HISTORIC AND DESIGN REVIEW COMMISSION

February 20, 2019

HDRC CASE NO: 2019-055
ADDRESS: 135 E COMMERCE ST
LEGAL DESCRIPTION: NCB 106 BLK LOT 35 (WITTE BUILDING I SUBD)
ZONING: D,HE
CITY COUNCIL DIST.: 1
LANDMARK: Witte Building
APPLICANT: Andrew Douglas/Douglas Architects
OWNER: 135 E Commerce, LLC
TYPE OF WORK: Amendments to a previously approved railing detail, installation of gas fueled tiki torches
APPLICATION RECEIVED: February 01, 2019
60-DAY REVIEW: April 02, 2019
REQUEST:

Railing Detail 1
Scale: 1" = 1'-0"

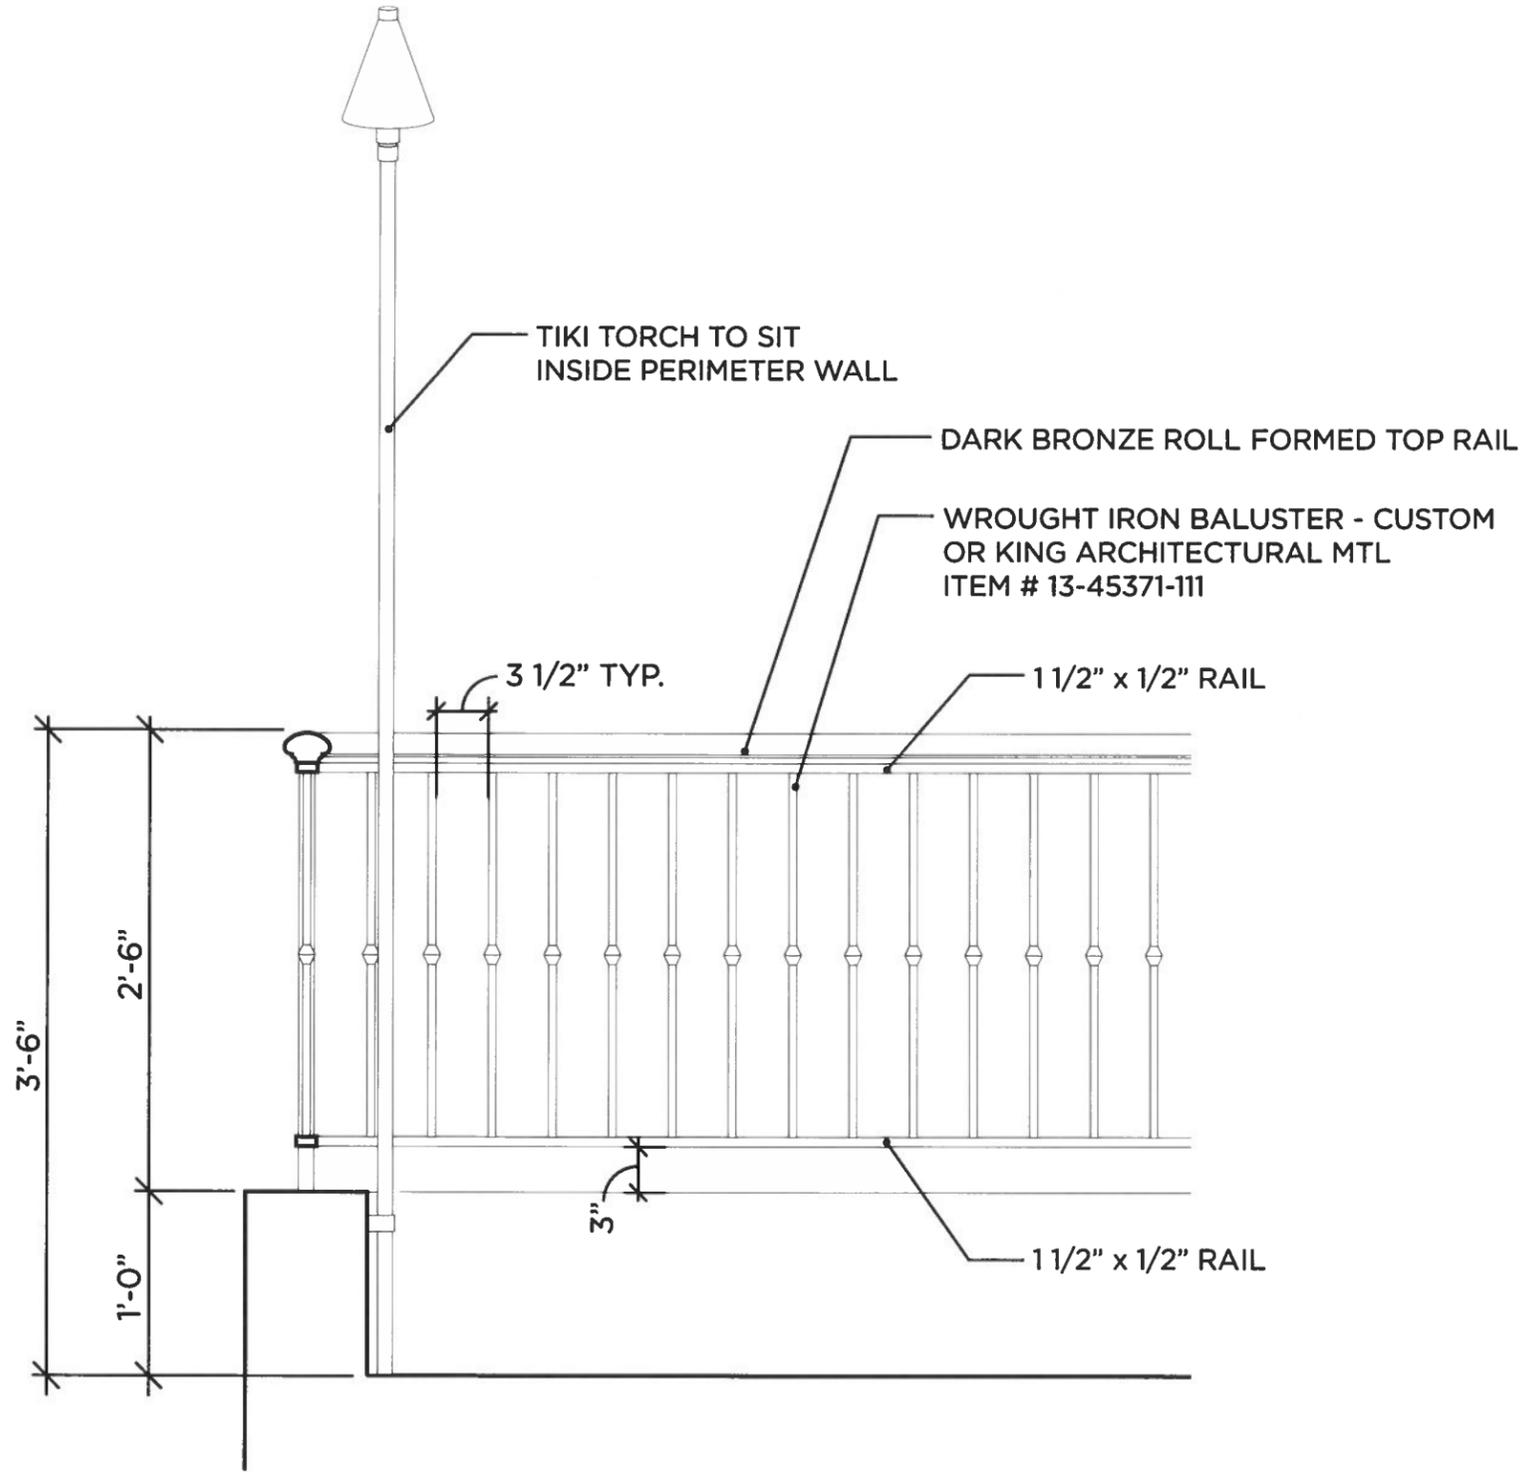
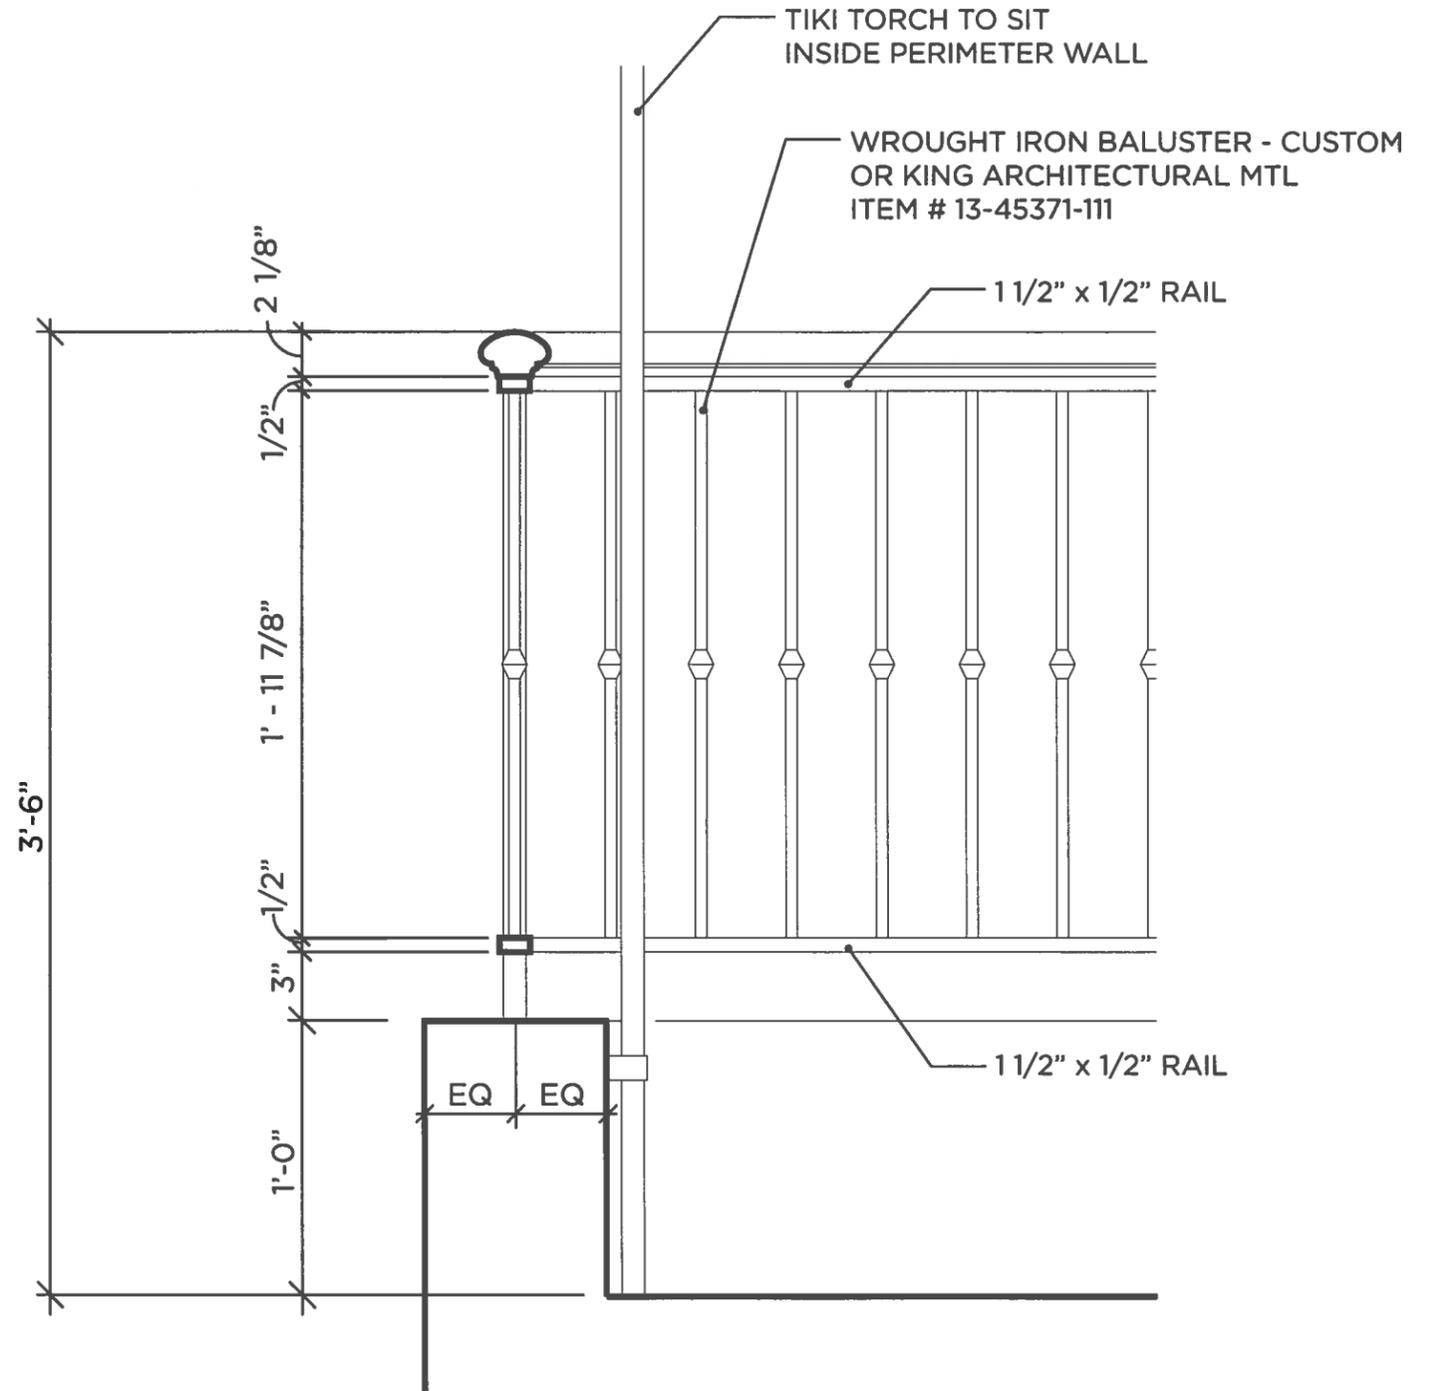
- c. TERRACE RAILING – The applicant has proposed to amend the previously approved terrace railing design. The applicant has proposed for the new terrace railing to consist of dark bronze roll formed top and bottom rails and wrought iron balusters. The applicant has submitted a detail of the proposed railing that includes dimensions. Staff finds the proposed terrace railing to be appropriate.

CHA - Witte Building
Tiki Torch Details
 Scale: 1/2" = 1'-0"

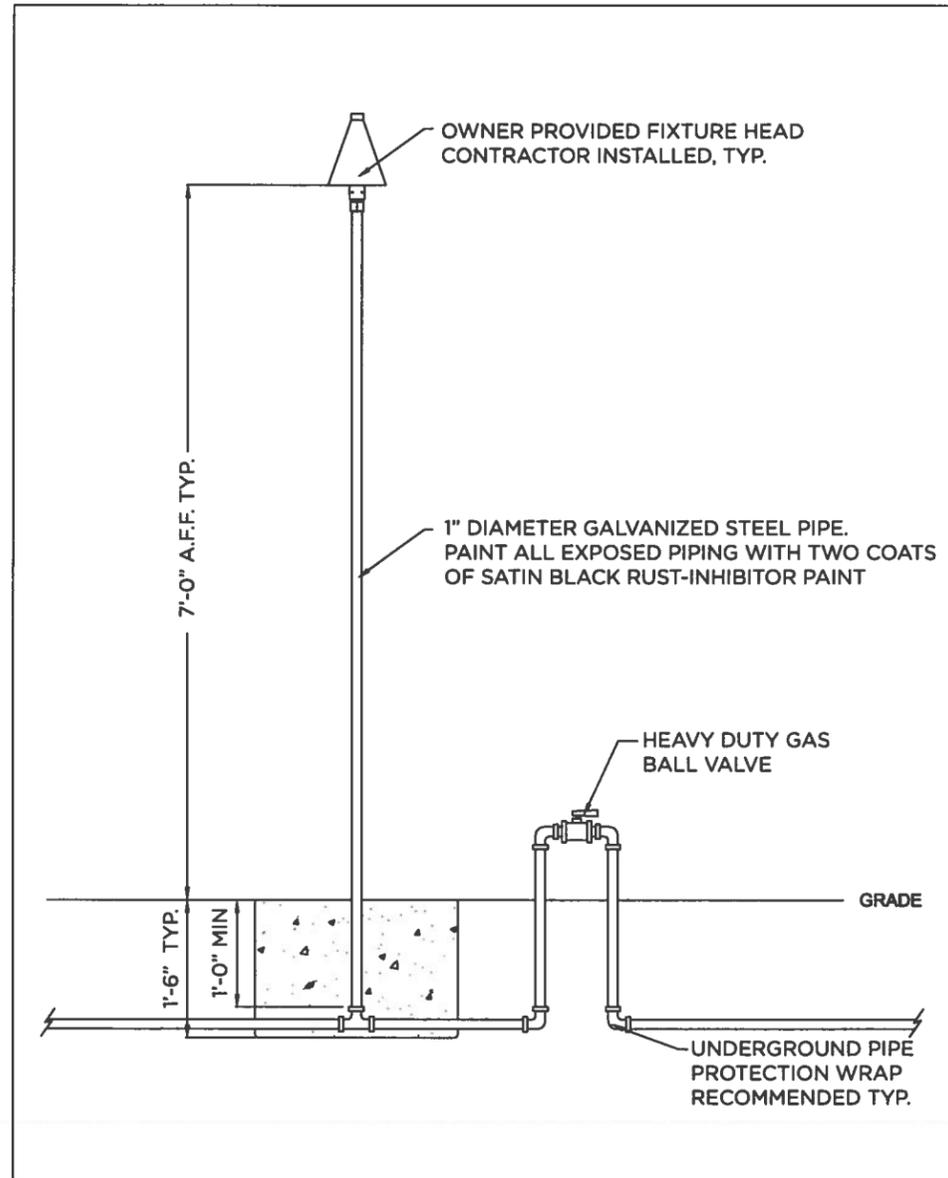
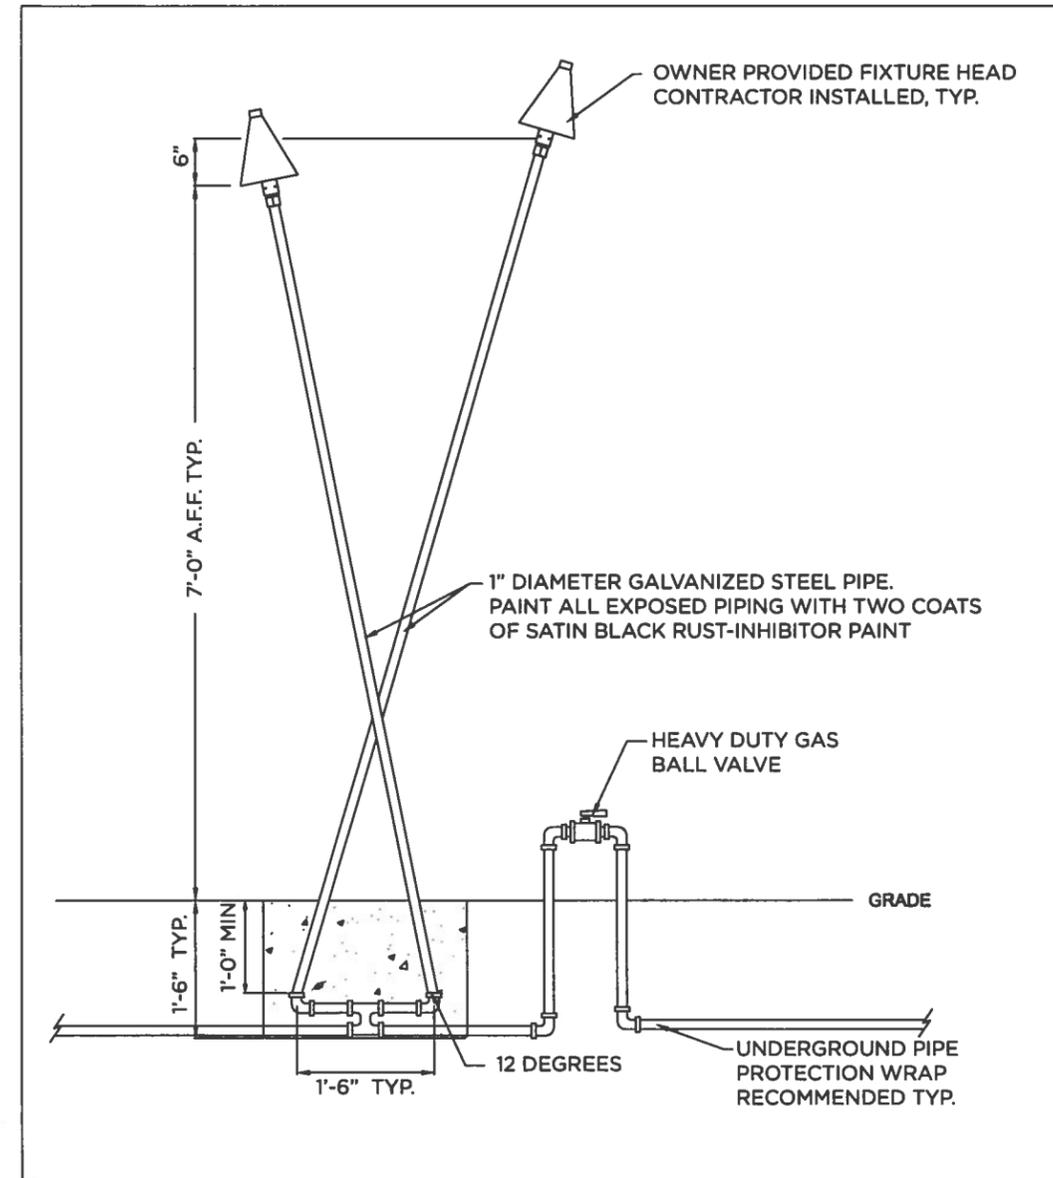
- d. TIKI TORCHES – Along both the north and west sides of the structure, the applicant has proposed to install a total of eleven tiki torches. The applicant has noted that the proposed tiki torches will feature a 1” diameter galvanized steel pipe which are to be painted satin black and be located within the exterior walls. The proposed torches will be installed in two separate profiles; vertically straight at a total height of approximately seven (7) feet in height and diagonally at a total height of approximately seven (7) feet in height. The applicant has noted that all tiki torches will be installed within the perimeter of the site walls.
